February 5, 2009  
NND-09-0020

Subject: Virgil C. Summer Nuclear Station (VCSNS) Units 2 and 3 Combined License Application (COLA) - Docket Numbers 52-027 and 52-028 Response to NRC Request for Additional Information (RAI) Letter No. 013

Reference: Letter from Brian C. Anderson (NRC) to Alfred M. Paglia (SCE&G), Request for Additional Information Letter No. 013 Related to SRP Section 13.03 for the Virgil C. Summer Nuclear Station Units 2 and 3 Combined License Application, dated January 6, 2009.

**SRP Section: 13.3 – Emergency Planning**

Figure 1: "Screen Capture of Census Blockpop Shapefile"

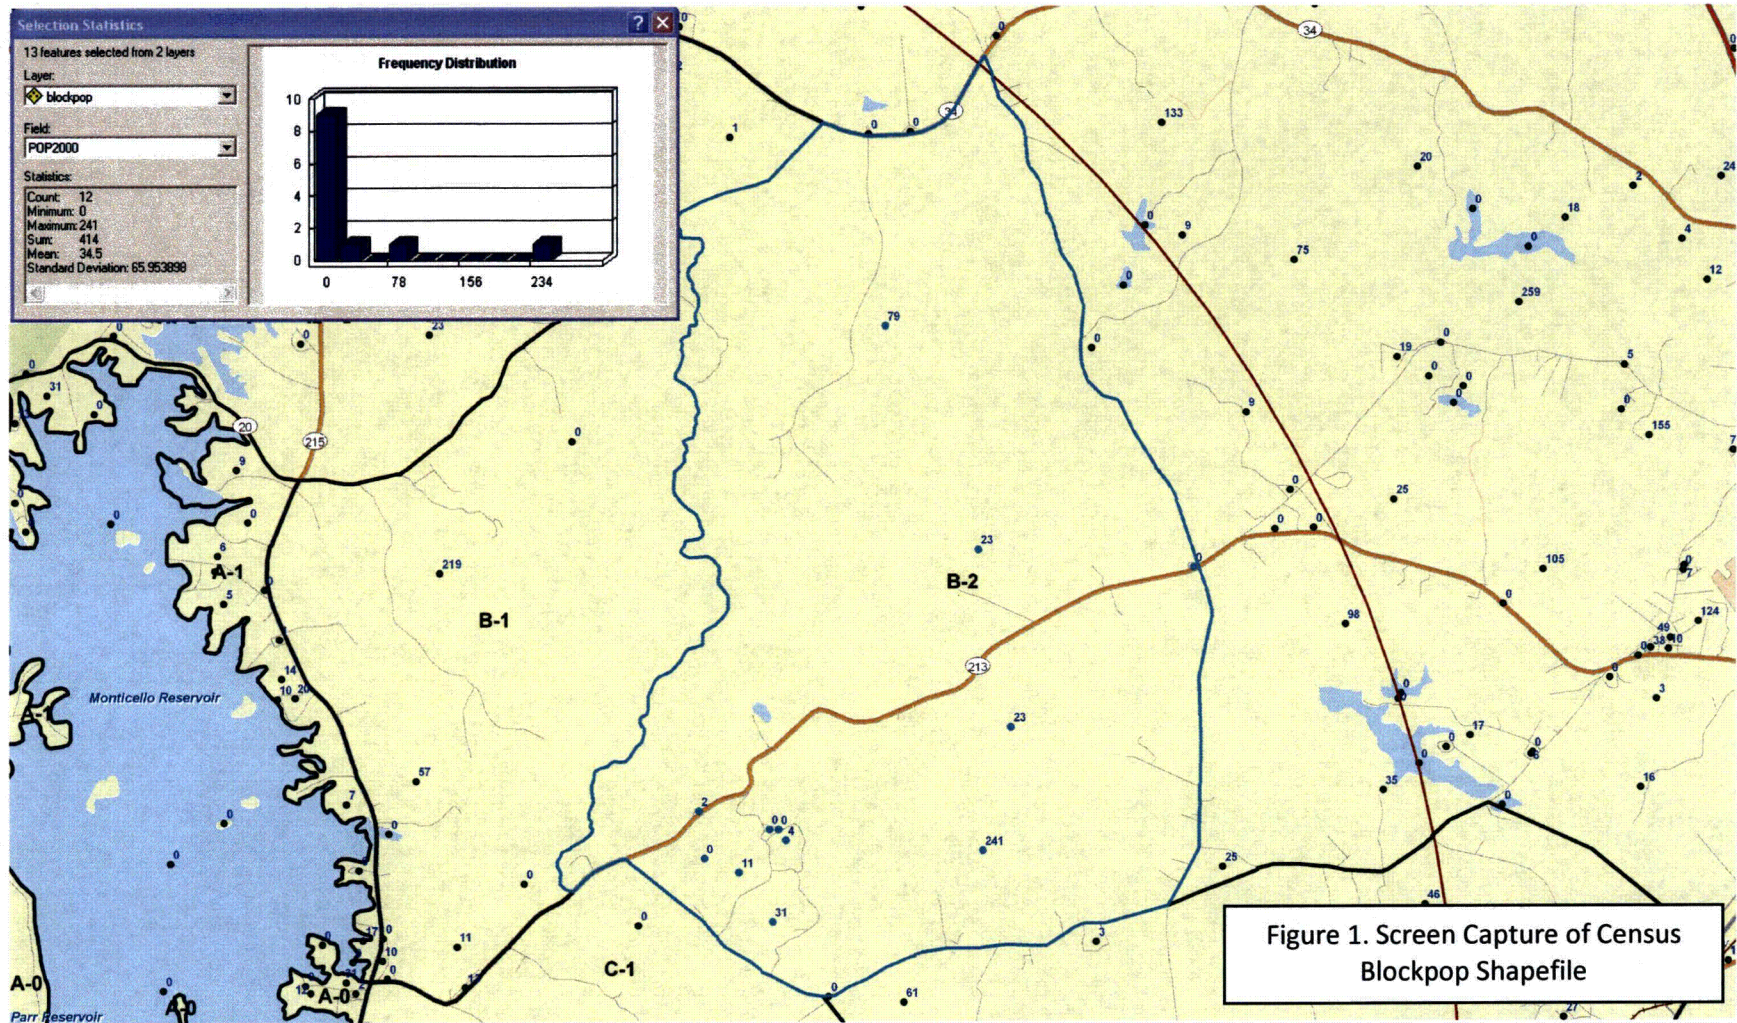
**D.** Explain the difference between population estimates in county plans and the ETE for the following sections:

- D. The population calculated in the ETE uses the 2000 US Census “blockpop” Geographical Information Systems (GIS) point shapefile. The “blockpop” shapefile divides census blocks up into a series of points with a Year 2000 population value assigned to each point. These points are located in neighborhoods and other populated areas. Thus, the shapefile provides a level of Census detail which is finer than the block level. These “blockpop” points were then summed for each PAZ using GIS software to provide a Year 2000 permanent resident population estimate. The attached Figure 1 provides a screen capture of the blockpop shapefile and its use in determining the population of a PAZ. As shown, all of the blockpop points in PAZ B-2 have been selected. The GIS software was used to sum these points providing a 2000 Population of 414, which matches the entry for PAZ B-2 in Table 3-1 of the ETE report.

1. Figure 1-1: "VC Summer Nuclear Station Site Location"
2. Figure 1-2: "VC Summer Link-Node Analysis Network" (on CD)
3. Figure 3-1: "VCSNS Protective Action Zones"
4. Figure 6-1: "VC Summer Protective Action Zones"

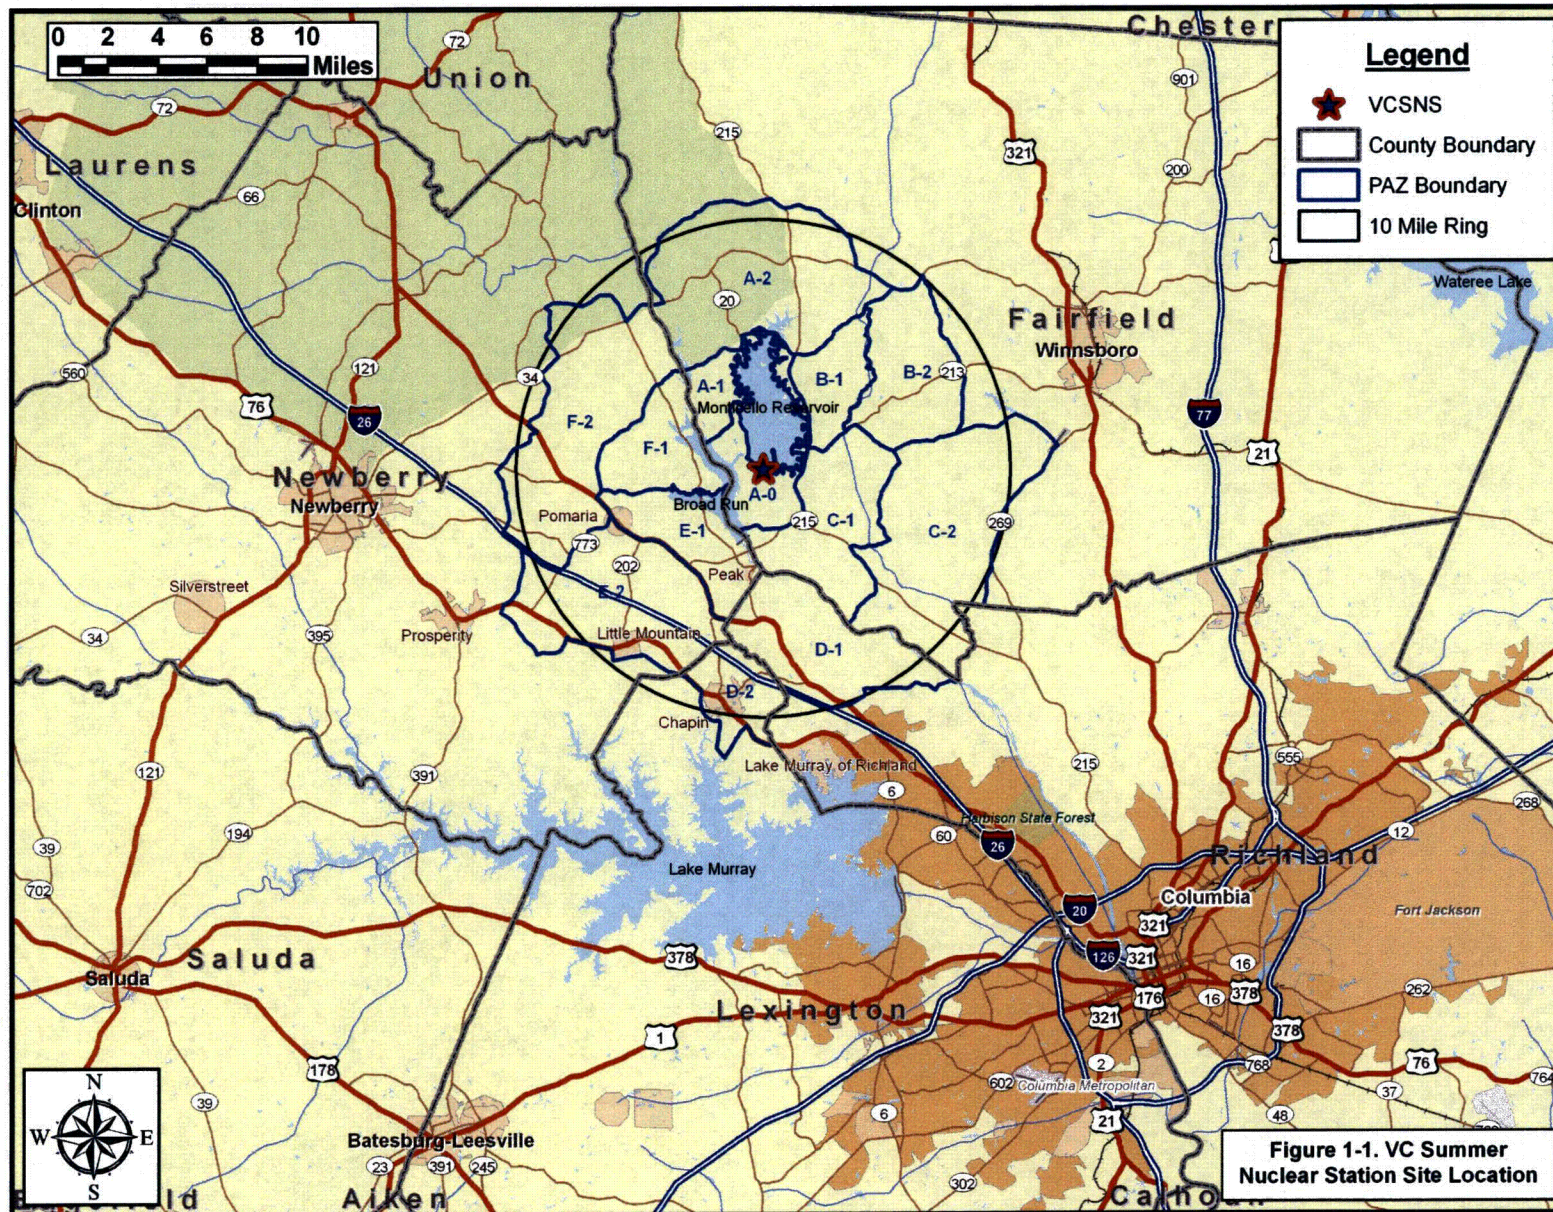
Figure 1-1, "VC Summer Nuclear Station [VCSNS] Site Location," shows the plant with associated Protective Action Zone (PAZ) boundaries within the plume exposure pathway Emergency Planning Zone (EPZ). The text on page 1-3 states that the figure identifies communities in the area, but only Newberry and Winnsboro are identified on the map. Fairfield County, Lexington County, and Richland County are not labeled. The county boundaries are not clearly defined in Figure 1-2, "VC Summer Link-Node Analysis Network," and Figure 3-1, "VCSNS Protective Action Zones." Information on elevation or land formations other than water body locations is also not provided. Provide a topographical map that includes elevations, surrounding communities, county boundaries, and political boundaries.

Labels have been added to Figure 1-1 for the lakes, rivers, and the communities in the area. County boundaries have also been added and labeled in Figure 1-1. The revised Figure 1-1 is attached and will be included in a future revision of the ETE report.

Figures 1-1, 3-1 and 6-1 are revised as attached and will be included in a future revision of the ETE report.

Figure 1. Comparison of ETE and Trip Generation Time  
VC Summer Nuclear Station  
Evacuation of Region R03, Scenario 1

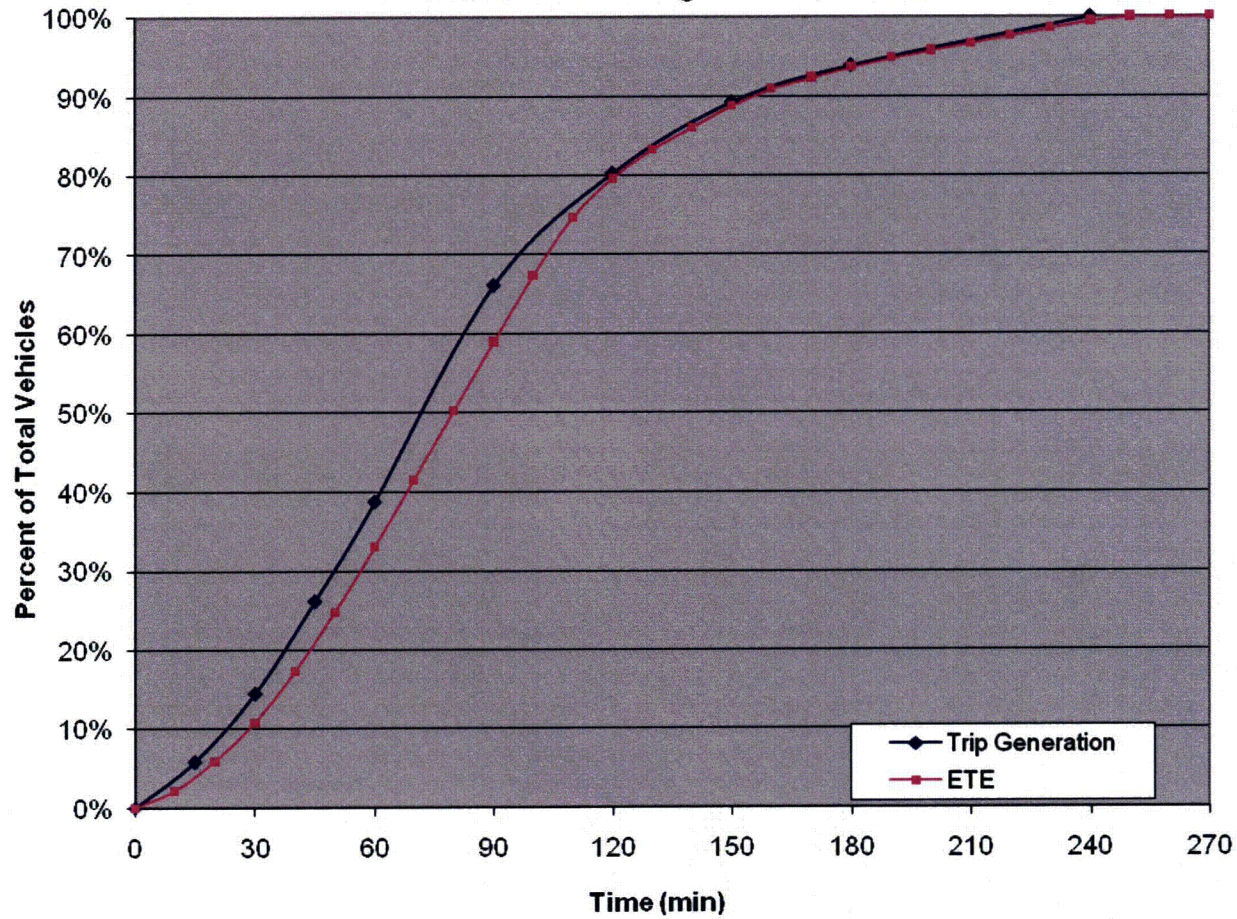
- A.** Section 2.3, "Study Assumptions," Assumption #3, states schools may be evacuated prior to notification of the general public. Table 8-5A, "School Evacuation Time Estimates-Good Weather," estimates that it will take on average of 1 hour and 56 minutes to evacuate the schools in the plume exposure pathway Emergency Planning Zone. If the assumption is correct, then the general public would not be notified until 2 hours after the emergency is declared. Provide clarification of Assumption #3.

The attached Figure 1 illustrates that the ETE for the VCSNS EPZ is dictated by the mobilization time. The horizontal distance between the trip generation curve and the ETE curve represents the travel time to the EPZ boundary. The short travel times indicate there is not pronounced traffic congestion within the EPZ delaying the departure of evacuees from the EPZ. Therefore, the establishment of TCPs strictly to manage traffic congestion is not necessary; however, the establishment of TCPs is recommended to provide guidance and reassurance to evacuees, and fixed point surveillance as noted above.

**Figure 3-6. Employee Population by Sector**

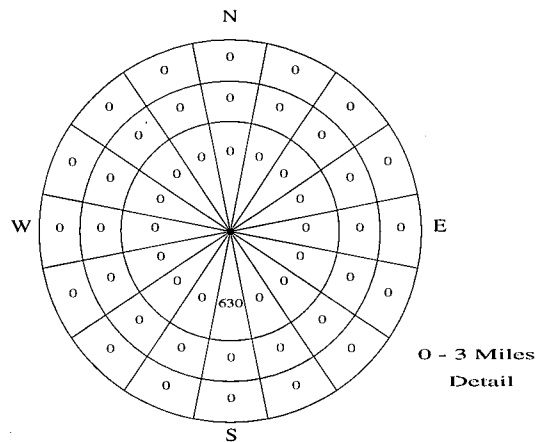
- B.** The text in Section 3, "Demand Estimation," states Figures 3-6, "Employee Population by Sector," and 3-7, "Employee Vehicles by Sector," present non-EPZ resident employee data by sector. Figure 3-6 is not provided. It has been replaced by a duplicate of Figure 3-4, "Transient Population by Sector." Provide Figure 3-6, "Employee Population by Sector."

- B. Figure 3-6 will be replaced in a future revision of the ETE report with the attached version of Figure 3-6, which identifies the employee population by sector.

Replace figure on page 3-12 with Figure 3-6 "Employee Population by Sector".

**Figure 5-1. Events and Activities Preceding the Evacuation Trip**

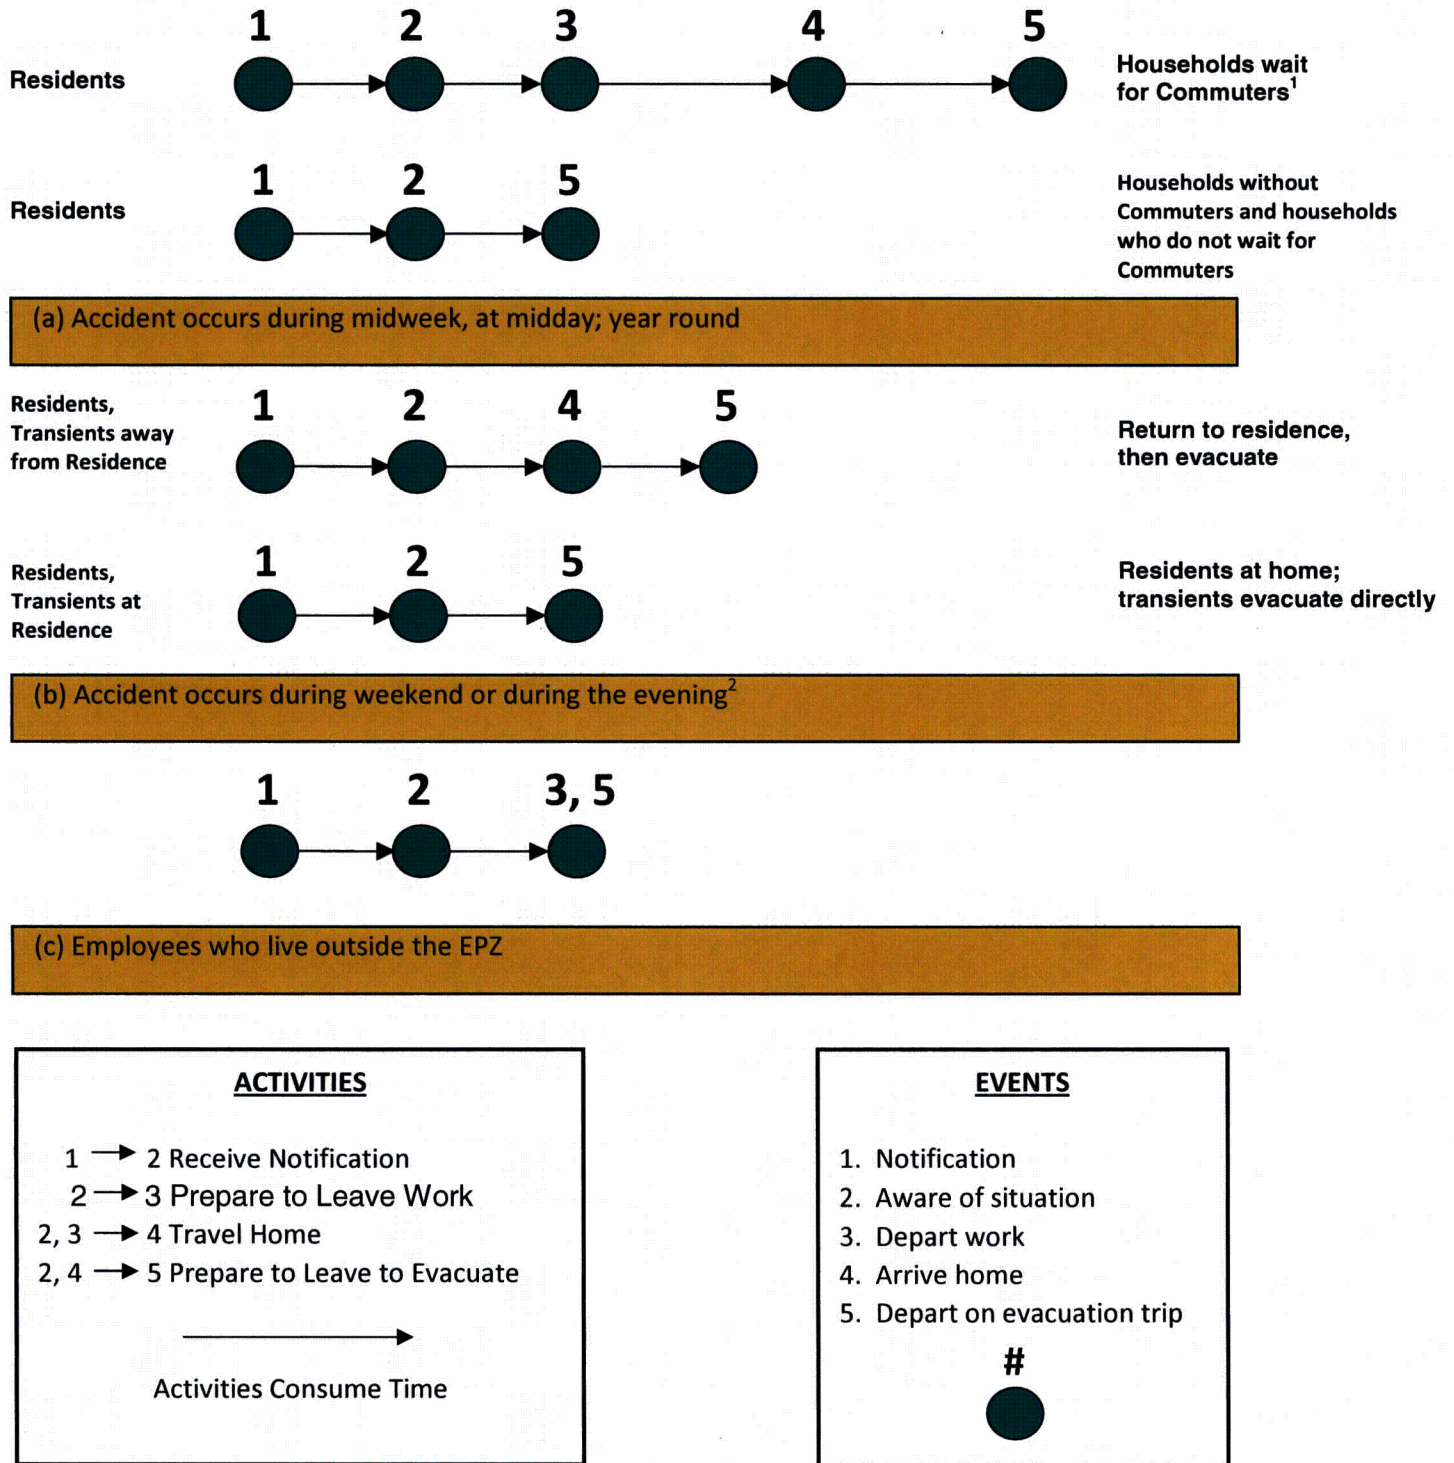
- D.** Figure 5-1, "Events and Activities Preceding the Evacuation Trip," shows that transients will be notified, become aware of the incident, and then evacuate the area. The figure suggests that transients would not be returning to their "residence" prior to evacuation. Explain why the possibility for transients returning to a location to gather belongings was not considered in the evacuation time estimate.

The existing Figure 5-1 has been reviewed; the diagrams for scenarios (b) and (d) do not include those households with employees who work during the evening or on weekends. Figure 5-1 is revised as attached to clarify its meaning and will be included in a future revision of the ETE report. The final paragraph on page 5-3 (continues on page 5-4) will be revised in a future revision of the ETE report:

Replace Figure 5-1 with the attached version of the figure.

Figure 5-2. Evacuation Mobilization Activities

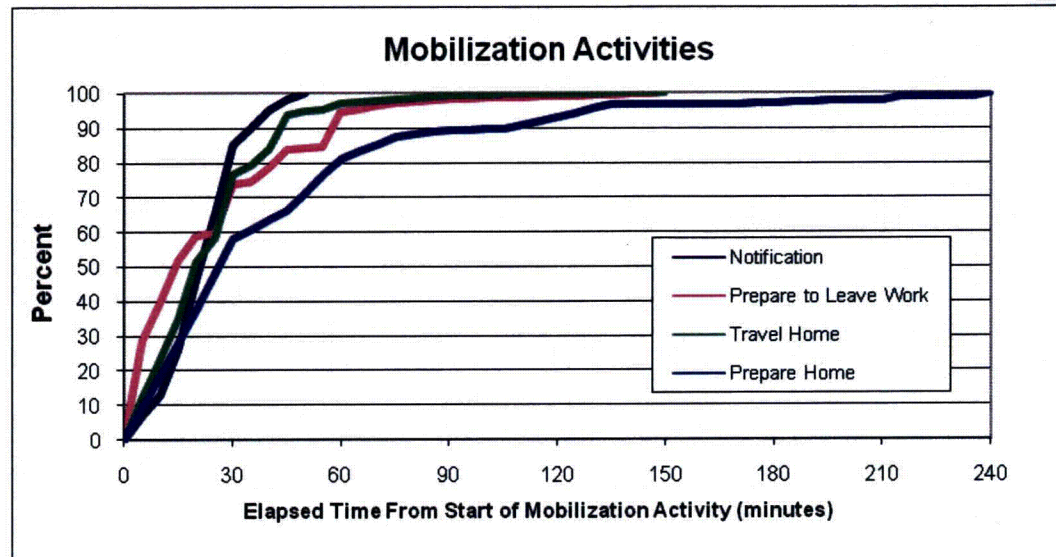
- C.** Appendix F, Figure F-11, “Time to Prepare Home for Evacuation,” indicates that as much as 360 minutes, or 6 hours, are required for the maximum time needed for the last individuals to prepare to evacuate. They must then travel out of the EPZ. Table 7-1D, “Time to Clear the Indicated Area of 100 Percent of the Affected Population,” indicates the longest evacuation time is 4 hours and 10 minutes. Explain how the data in Figure F-11 were used in the development of the ETE.

The curves in Figure 5-2 and Figure 5-3 do not reflect the results of this procedure whereby the trip generation of the stragglers is advanced; both figures will be replaced in a future revision of the ETE report with the attached versions. As shown in the attached Figure 5-3, the trip generation process is complete at 4 hours after the advisory to evacuate, which agrees with the tabular distribution shown in Table 5-1 of the ETE report.

Figure 5-3. Comparison of Trip Generation Distributions

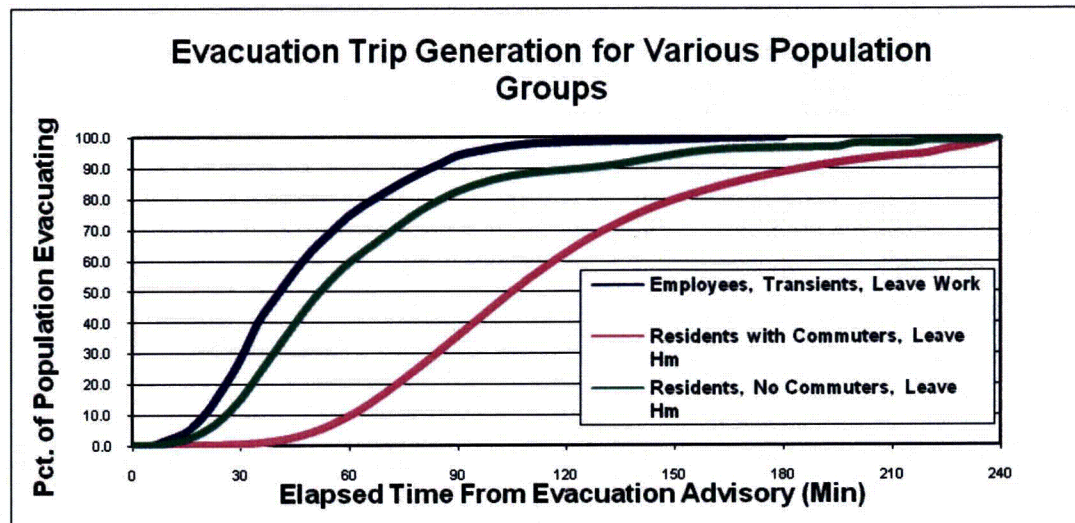
- D.** The curves in Figure 5-3, “Comparison of Trip Generation Distributions,” appear to end at approximately 97% of population evacuating. Discuss whether these curves are intended to approach 100 %, or whether the elapsed time axis should be extended.
